## INA Service Info

# Tensioner arm 533 0075 30

## Be sure to observe screw length

Photo: Right, old design / left, new design

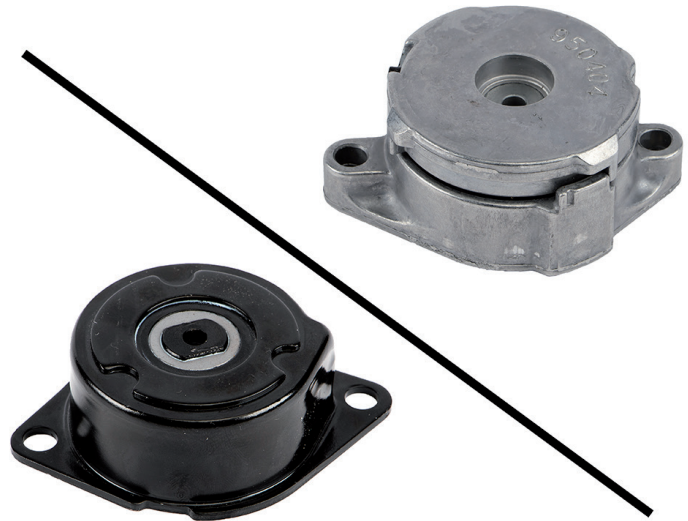
As part of the ongoing development of our products, tensioner arm 533 0075 30 has been modified. Proper installation of this new design requires shorter screws. The M8x35 screws have been replaced by M8x22 screws.

The Service Information bulletin shows the visual features of the previous design (pictured at right) and the new design (pictured at left).

For correct repair using the new tensioner arm 533 0075 30, only M8x22 size screws may be used!
